Application of MicroLife Institute to rezone property from R-75 (Residential Medium Lot-75) zoning district to R-60 (Residential Small Lot-60) zoning district to allow for a cottage home development, at 2883 and 2893 Midway Road.

PETITION NO: N1-2025-0045 Z-25-1247356

LOCATION: 2883 and 2893 Midway Road, Decatur, Georgia 30030

STAFF ANALYSIS

PROPOSED SITE PLAN

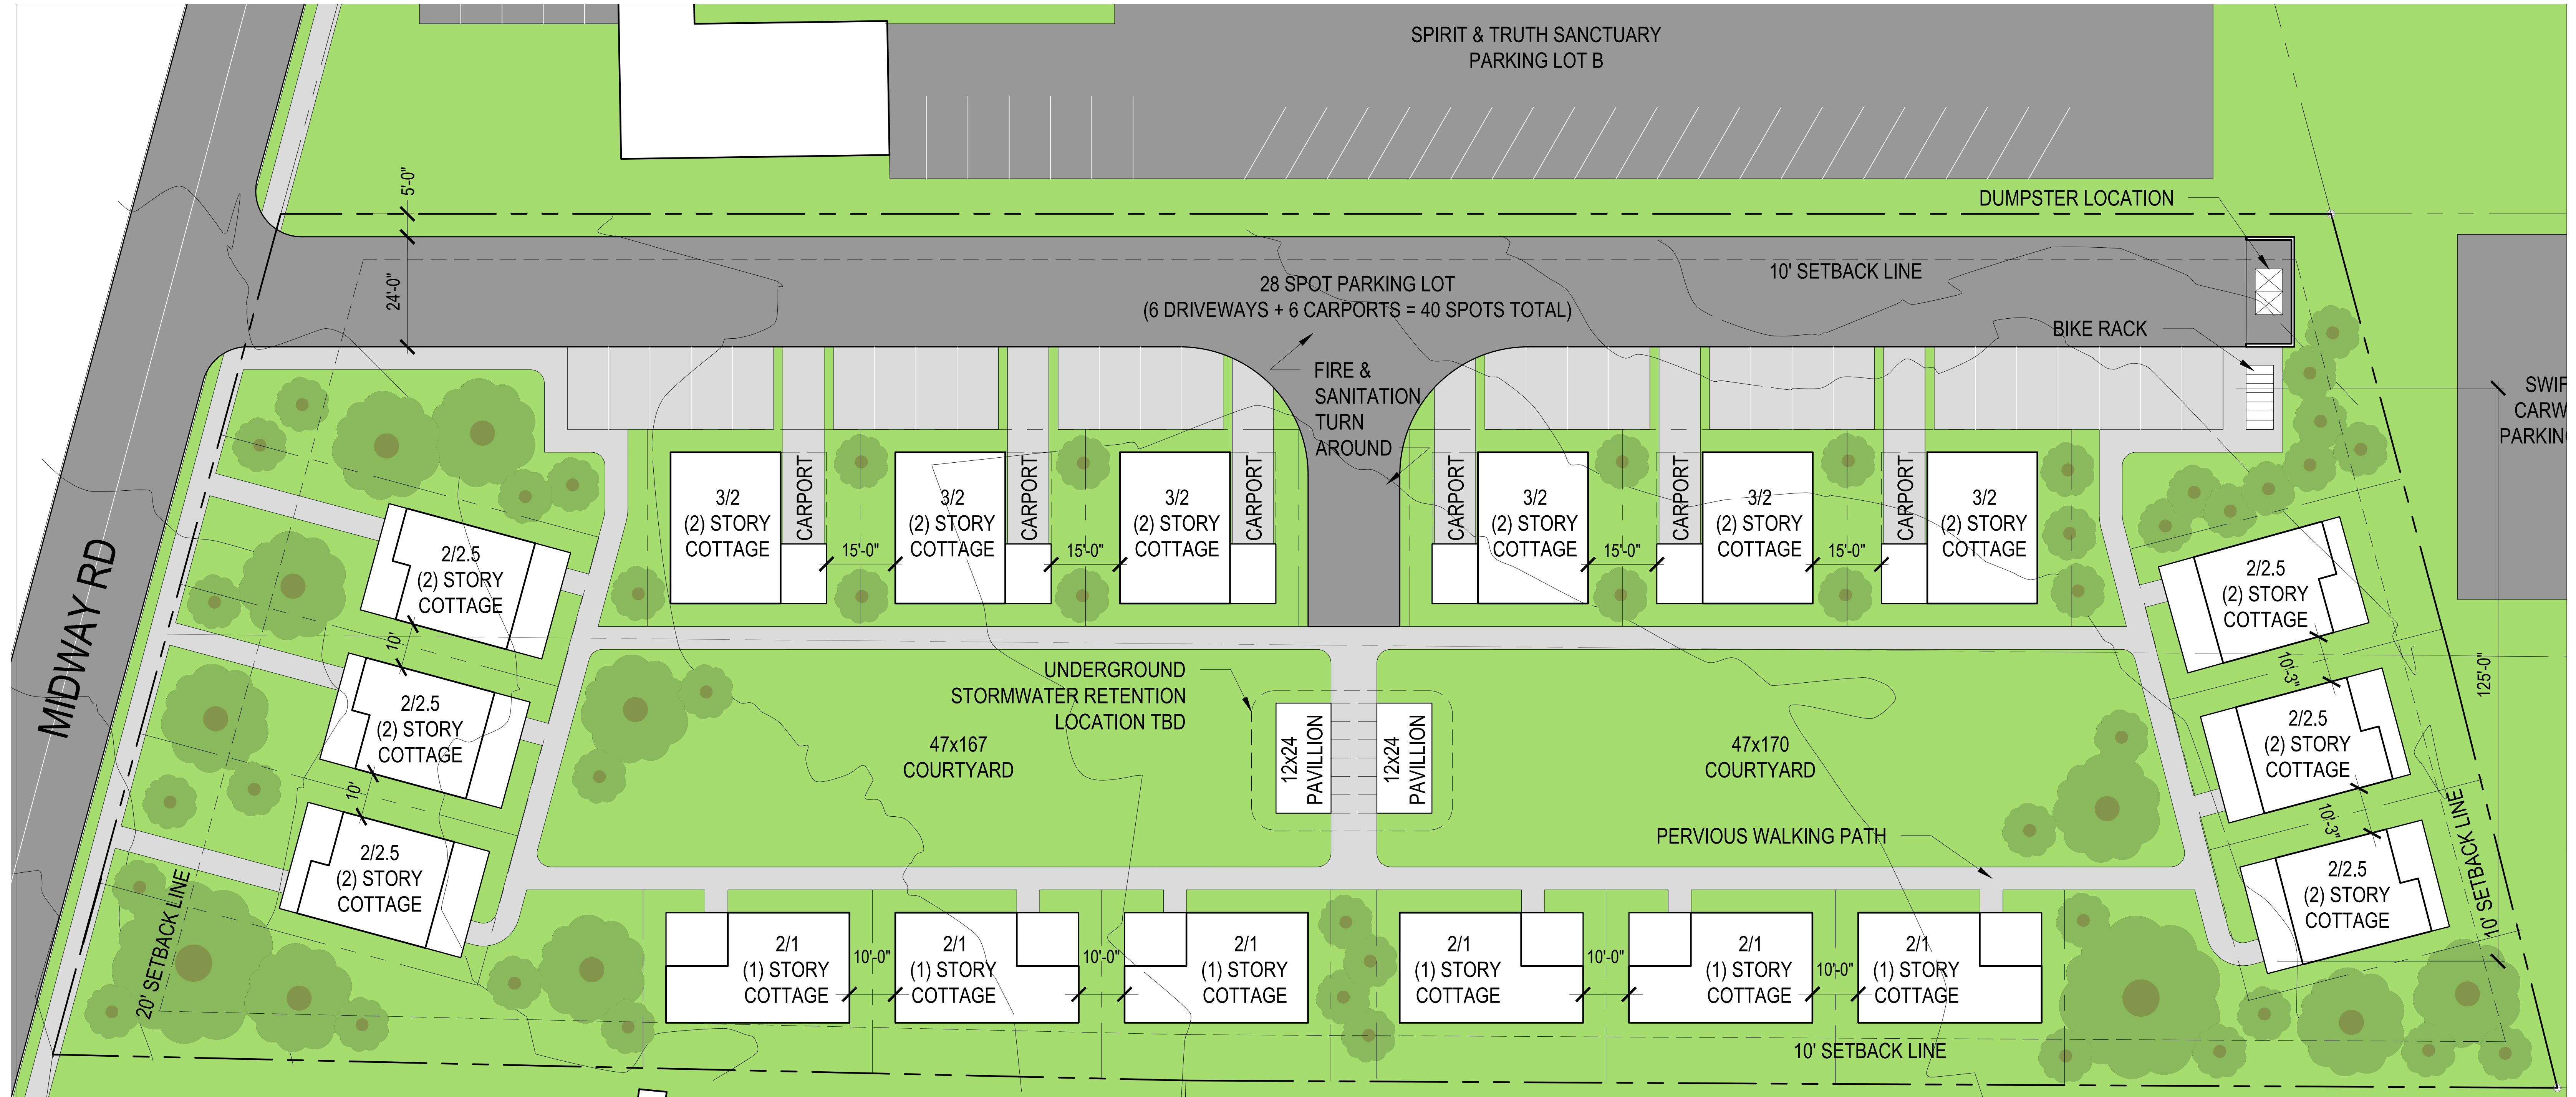
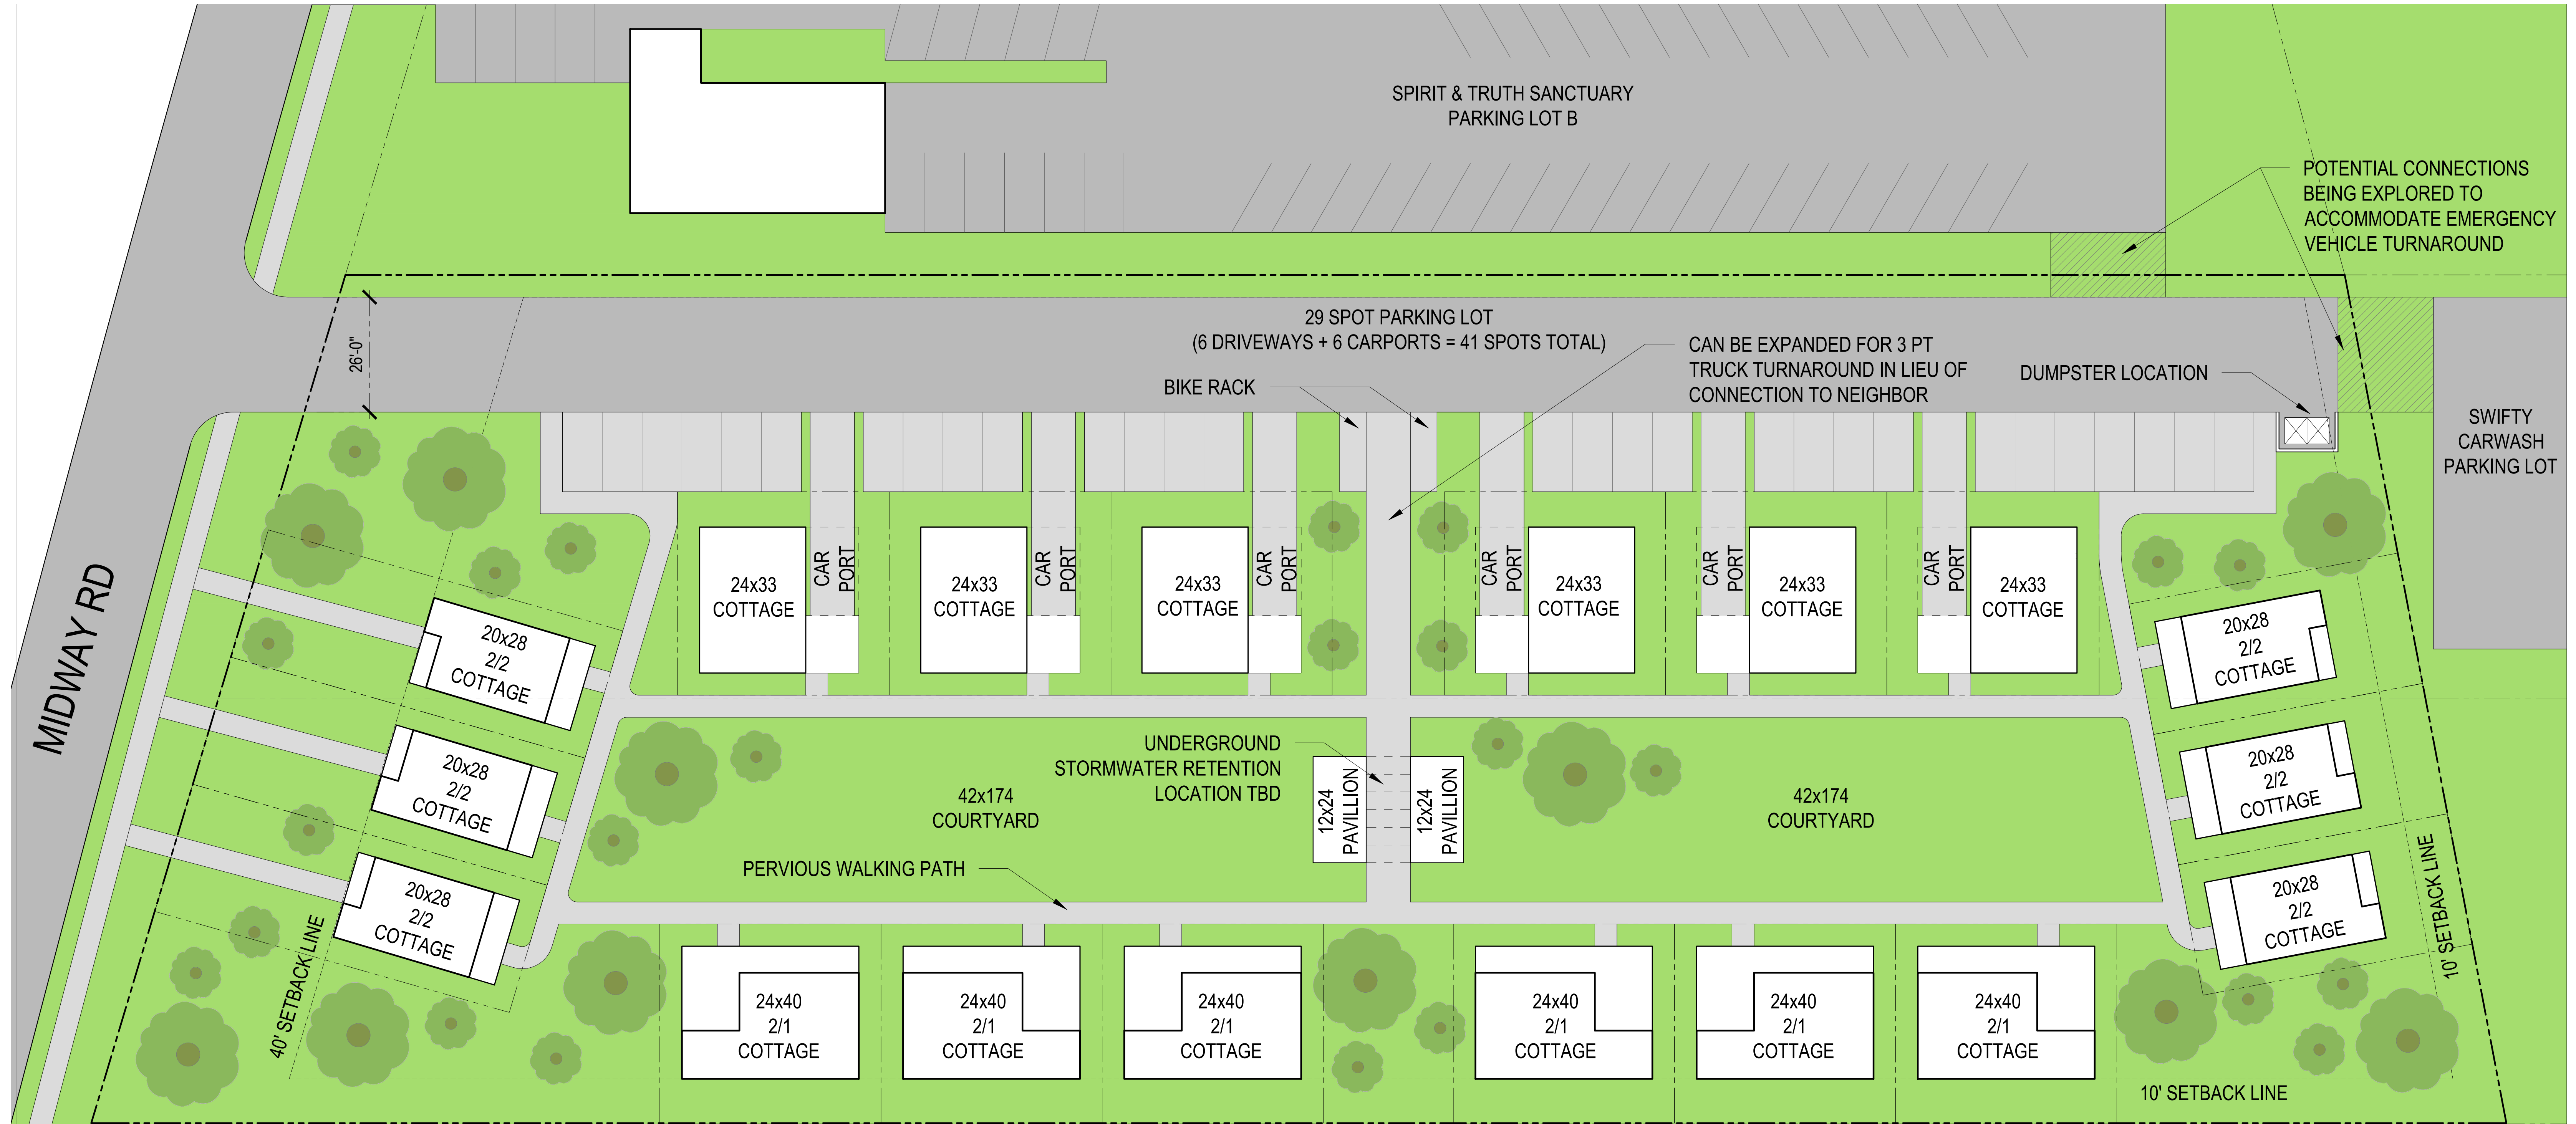
Updated Site Plan (Version 2 - 3/10/2025) Review:

The revised site plan now incorporates an official survey, improving accuracy over the previous GIS-based estimate. Key adjustments include an updated alley design (Condition 4) that enhances fire and sanitation access, along with a relocated dumpster for improved serviceability. A sidewalk connection (Condition 7) links the existing Midway sidewalk to the common area. Further refinements include verification that the maximum cottage-to-parking distance remains under 200' (Condition 9), a reduction in total parking spaces from 41 to the allowed 40, and a corrected front setback of 20' to align with adjacent properties. The cottage footprints have also been refined while maintaining compliance with Condition 2. All other conditions are either already addressed or will be incorporated as the plan progresses. As this remains a preliminary, in-house version, a licensed Civil Engineer will finalize the sketch plat, ensuring compliance with additional conditions, including tree recompense, stormwater management, and detailed landscaping.

Furthermore, the Applicant will need to verify the proposal complies with 27-5.7.9 **(D2)** *lot coverage and open space* and **(J)** *Additional Cottage Development Elements*. Other interdepartmental comments (enclosed) to be considered:

- 4) Proposed cottages shall be located and centered around a common area of enhanced open space in general conformance to that shown on the site plan dated 03/10/2025 and titled “*Version 2*”. The site plan is conceptual, however, and the location of the dwelling units may be altered to better support other required improvements, such as emergency vehicle “T” turn around as described herein, off-street parking, and storm water detention facilities, subject to approval of the Planning Director. All dwelling units shall be within 60 feet walking distance along the shortest safe walking route to the nearest point of the common open space.
